# DART SERVICE INSTRUCTION

TO AMEND INSTALLATION INSTRUCTIONS IIN-D407-797-1 REV. B AND EARLIER,  
INSTALLATION INSTRUCTIONS IIN-D206-797-2 REV. B AND EARLIER, AND  
INSTRUCTIONS FOR CONTINUED AIRWORTHINESS ICA-D407-797 REV. 1 AND EARLIER

REF. TCCA STC: SH11-1  
REF. FAA STC: SR02996NY  
REF. EASA STC: 10035429

**FIGURE 1: D3915-041 BASKET LID ASSY (LIGHT WEIGHT)**

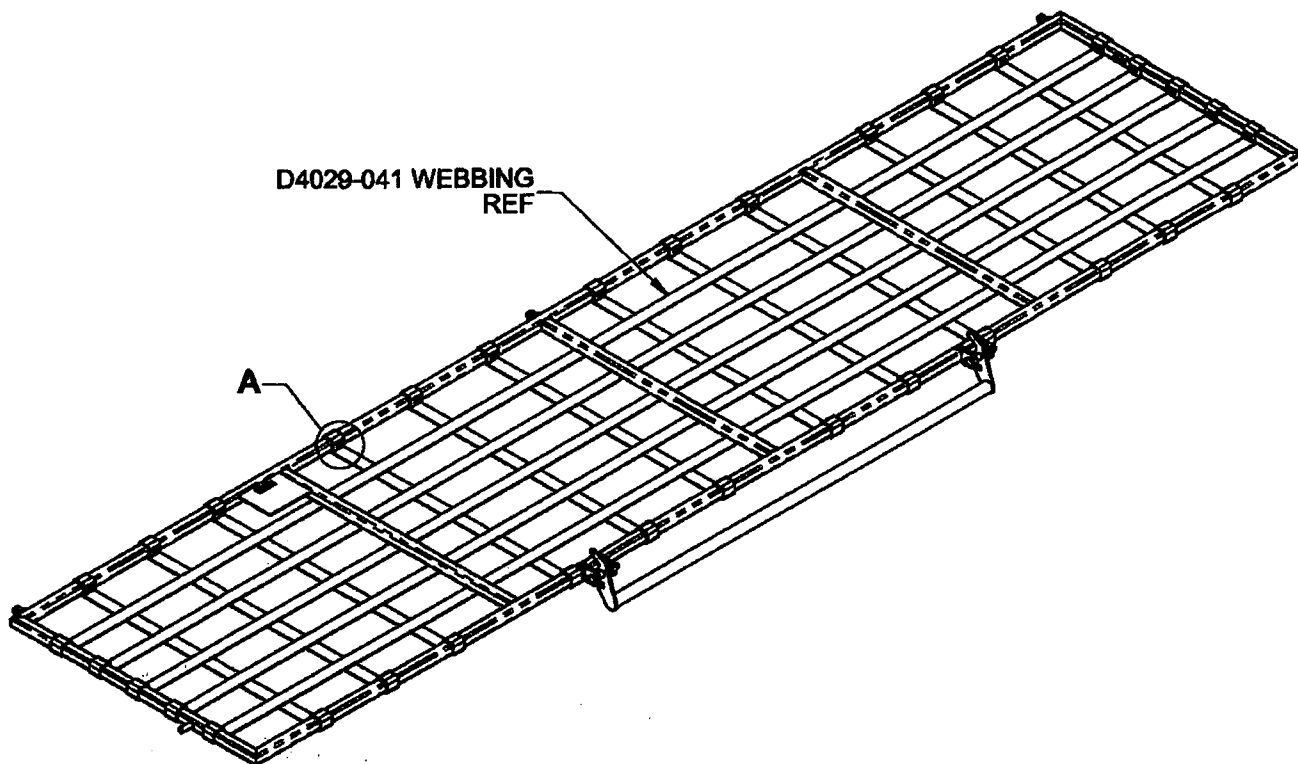
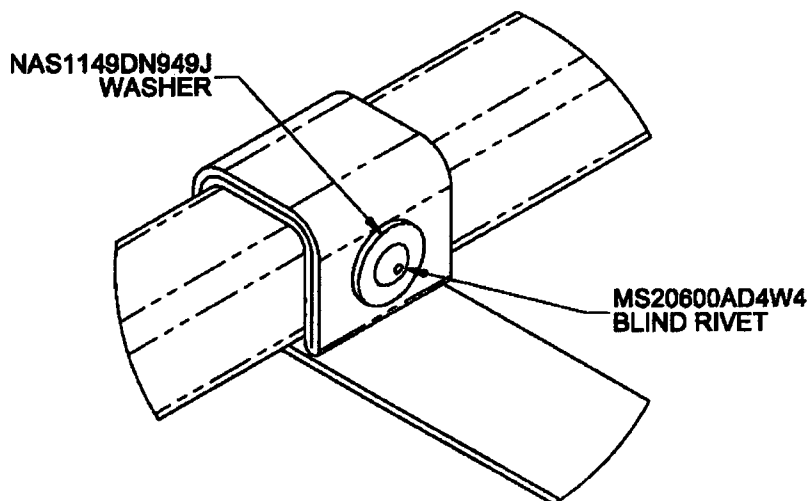
It has come to DART's attention that the webbing strands of the cargo net riveted to the structure of the lightweight lids on D407-797-013/-014 and D206-797-023/-024 Hell-Utility-Baskets at CHG 004 and earlier may pull through the small washer and rivet head and detach during operation.

The purpose of this service instruction is to provide parts and instructions to replace the NAS1149DN416J Washers and MS20600AD4W3 Rivets fastening the webbing strands of the cargo net onto the structure of the lightweight lids with NAS1149DN949J Washers and MS20600AD4W4 Rivets.

- 2.1 Carefully remove existing rivets and washers attaching the webbing to the lid frame without enlarging holes in the webbing or the lid frame.
- 2.2 Inspect the basket lid structure in accordance with ICA-D407-797. It is acceptable to inject Sikaflex -241/-291 or Proseal 890 or MIL-S-8802 Class B2 sealant into the lid structure to trap rivet debris inside the tubular structure. Repair and touch up finish as required.
- 2.3 Inspect the D4029-041 Webbing for wear. The maximum acceptable hole size is Ø0.188" (4.8 mm). Replace the webbing if holes are larger than Ø0.188" (4.8 mm) or if the webbing is worn or cuts have been found.
- 2.4 Re-install the webbing as shown in Figure 1 of this service instruction

**Note:** It is acceptable to upsize rivets to MS20600AD5W4 (customer supplied) and enlarge the holes in the basket lid structure to Ø0.156" (3.96 mm) if holes were enlarged at Step 2.1.
